ADDENDUM

Date Issued:	Nov 13, 2024
Project:	Intermountain Health Intermountain Kidney Services - Ogden Kidney Clinic 1100 Country Hills Drive, Ogden, UT 84403
Addendum Number:	1

ADDENDUM #1

PROJECT: Ogden Kidney Clinic

G002

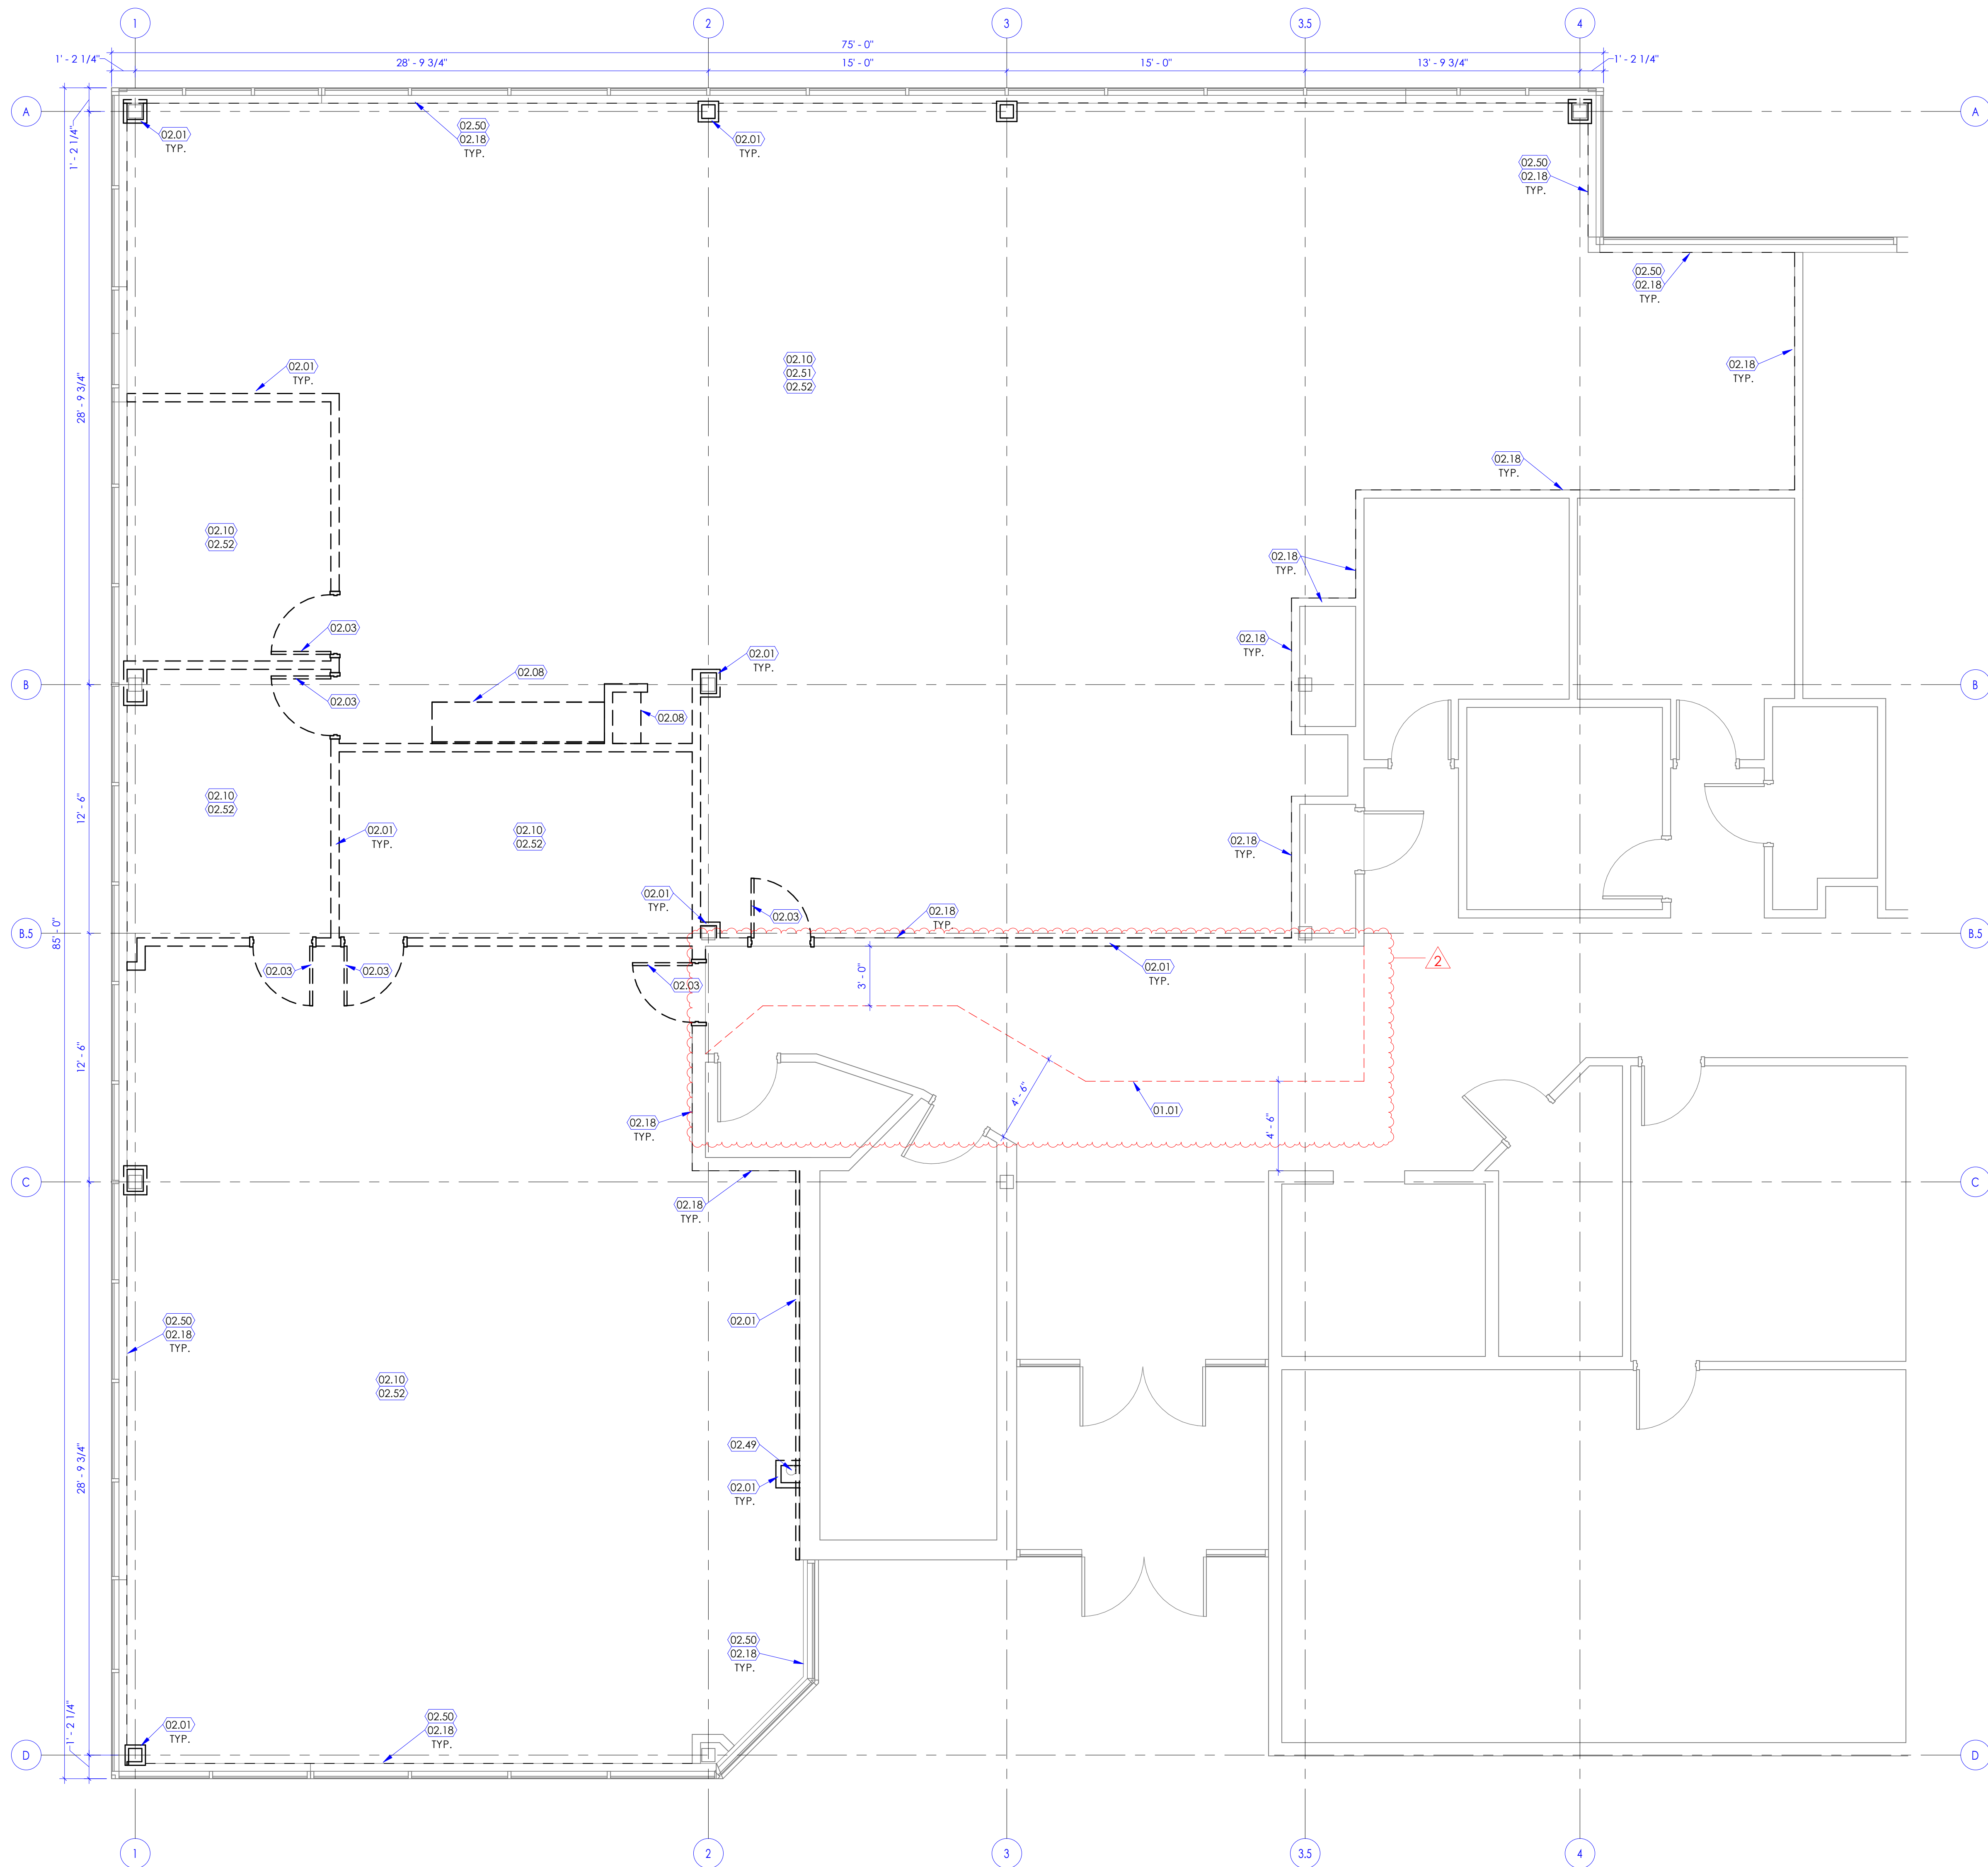
Sheet Number	Drawings
Architectural Drawings	
G002	Removed ICRA information.
A111	Added prefabricated ICRA walls in lobby area for work at the waiting/storefront system and above ceiling M/E/P work.
Mechanical Drawings	
See Mechanical Addendum 01
